SUNDRY NOTICES AND REPORTS ON WELLS

Proposed Plugging Procedure Attachment to 3160-5

Gillespie Federal #1 - 30-045-26611

Re: Permanent Abandonment
Well: 1 Gillespie Federal

Proposed P&A

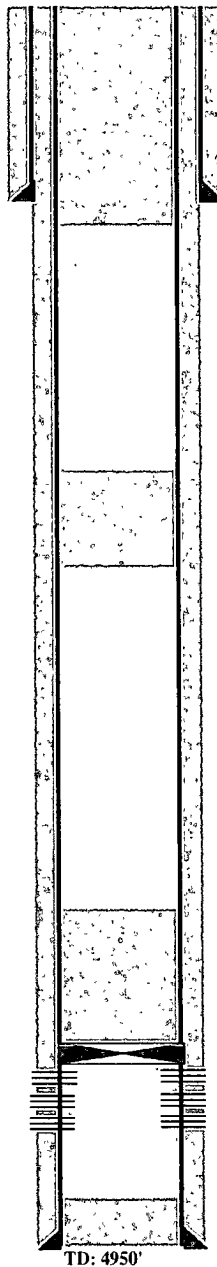
see added mancos and chacra plugs

Plug *Proctored Cliffs / Fruitland* 1128'-885'
Plug *Kirchland / Ojo Alamo* 648'-354'

Plug *Mancos* 3663' - 3563'
Plug *Chacra* 1478' - 1378'

1. Plugging operations authorized are subject to the attached "General Requirements for Permanent Abandonment of Wells on Federal and Indian Lease."
2. Farmington Office is to be notified at least 24 hours before the plugging operations commence (505) 599-8907.
3. The following modifications to your plugging program are to be made:
 - a) Place the Mesaverde plug from 1846' – 1746'.
 - b) Place the Pictured Cliffs/Fruitland plug from 1128' – 885'.
 - c) Place the Kirtland/Ojo Alamo plug from 648' – 354'.
